NOTICE OF DENIAL

RE: Application Number 21-7395; 4784 Sturtevant Street, Russell Woods – Sullivan Historic District

CERTIFICATE OF APPROPRIATENESS

HISTORIC DISTRICT COMMISSION PROJECT REVIEW REQUEST

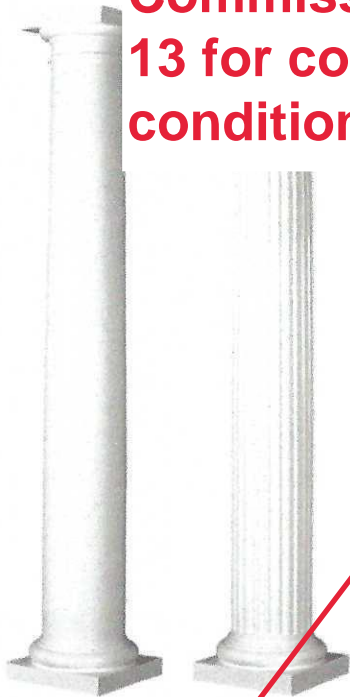
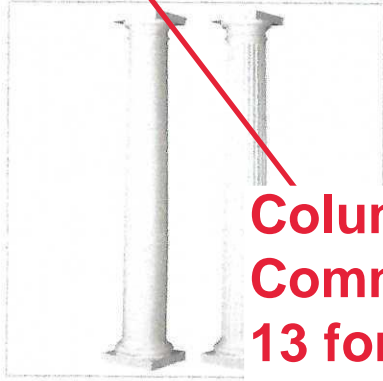
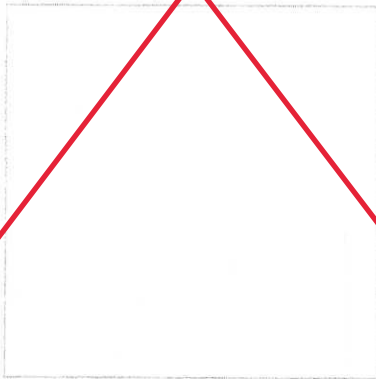
**Columns not approved by
Commission -- see pg. 12 &
13 for columns which meet
conditions set forth by HDC**

**Columns not approved by
 Commission -- see pg. 12 &
 13 for columns which meet
 conditions set forth by HDC**

4784 Sturtevant
Detroit, mi.
Front Porch Column

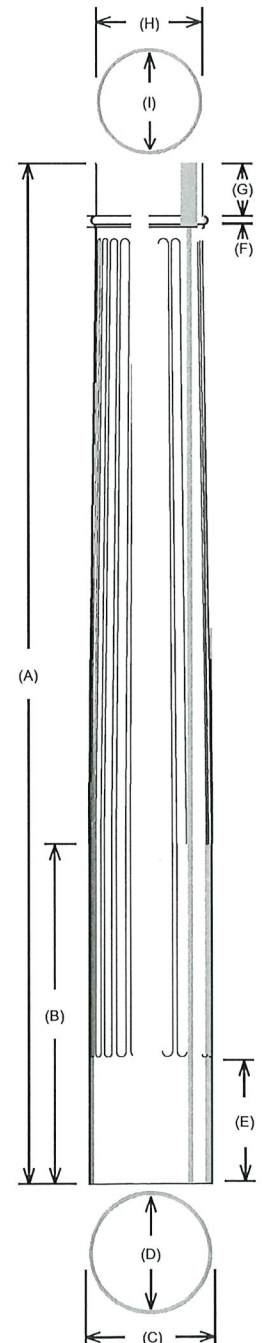
Columns approved -- meet conditions set forth by HDC that replacement columns match the appearance and size of existing wood columns

Columns approved -- meet conditions set forth by HDC that replacement columns match the appearance and size of existing wood columns
